Appeal Staff Report Addendum

Tentative Subdivision Plat

SD-01-24

June 10, 2024

Sheet **C1.1**
SCALE: SEE BARSCALE

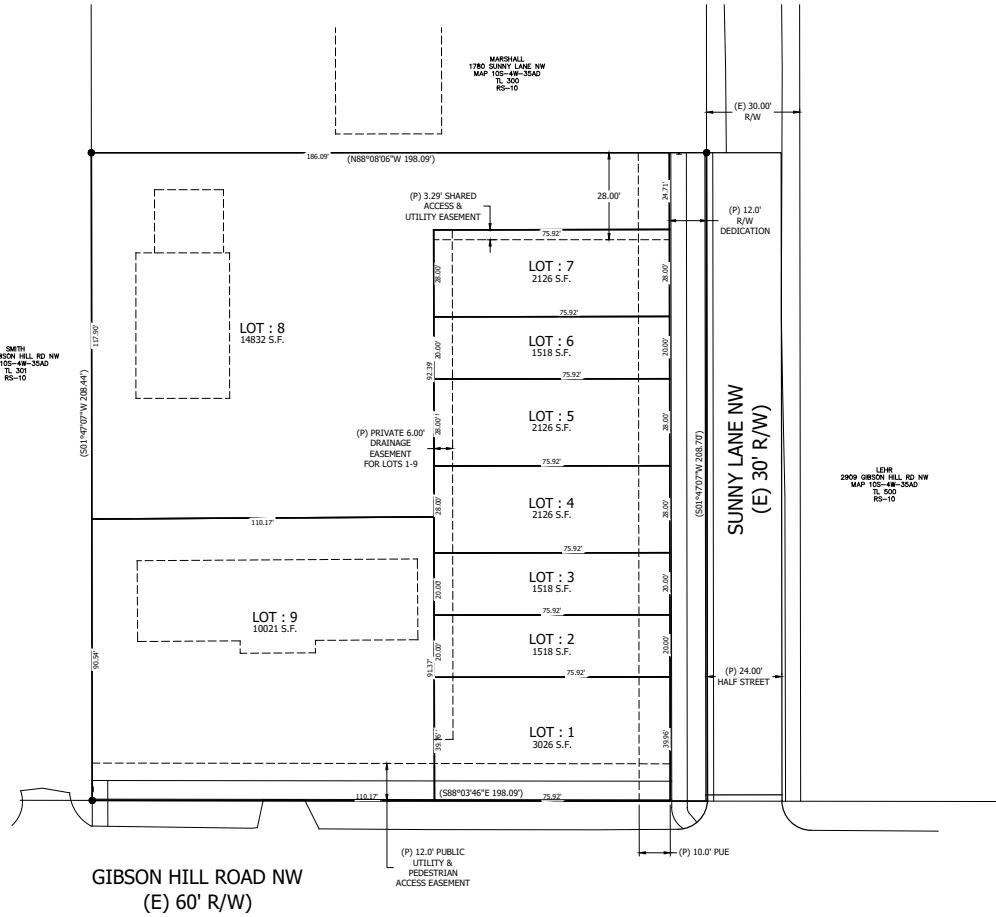
As proposed, Lot 8 and 9 would be approximately 60% of the original parcel, and the remaining area should be identified for townhouse development [13,958 sq ft as calculated according to sheet c1.1 Attachment B Tentative Plat by Udell Engineering and Land Surveying, LLC.]

ADC Residential District Development Standards were found on Table 3.190-1 and in section 3.191 (1) specify the minimum size lot for a townhouse is 1500 sq ft (goal met) and the maximum density for a townhouse project in RS-10 is 2,500 sq ft per *townhouse unit (emphasis added)* (goal not met.) Neither a duplex nor a barn/storage is a townhouse unit,

ADC 3.191(1)(a) states that the maximum permitted density for a townhouse project shall be based on the total area of the development site (including all townhouse lots and other tracts). A townhouse project is defined as one or more townhouse structures constructed, or proposed to be constructed, together with the development site where the land has been divided or is proposed to be divided to reflect the townhouse property lines and any commonly owned property. Because the subdivision did not contain any commonly owned property, only the townhouse lots (Lots 1 – 7) were used to calculate the maximum density of the townhouse project. Lots 8 and 9 were not included in the density calculation.

ADC 3.191(a) also states that for the purposes of calculating density, the gross area required for each townhouse unit in the RS-10 zone shall be 2,500 square feet per townhouse unit. Gross area is calculated to include the area of the site before any dedication or deductions of land are made for rights-of-way or open space. The gross area of the subject townhouse project is 16,164.9 square feet (see Attachment B). The gross area of the townhouse project divided by the maximum density of 2,500 square feet allows 6 townhouse units ($16,164.9 / 2,500 = 6.4$ units).

The subdivision also qualified for ADC 3.220 Bonus Provisions for Reduction in Lot Size Requirements. ADC 3.220(1) allows a residential development a 10 percent reduction in average minimum lot size where at least 50 percent of the lot area is located within 200 feet of a designated collector or arterial street, and the lot will not have direct access to an arterial. Gibson Hill Road NW is considered a minor arterial street and 100 percent of the townhouse lots are within 200 feet of Gibson Hill Road NW. In addition, access to all townhomes will be provided from Sunny Lane NW (Attachment B). The applicant has satisfied the requirements for a reduction in lot size; therefore, a 10 percent reduction to the 2,500 square feet allows each lot in the townhouse project to average 2,250 square feet. Based on the townhouse development project gross area of 16,164.9 square feet divided by 2,250 square feet ($16,164.9 / 2,250 = 7.18$ units), the maximum density allows 7 townhouse units.
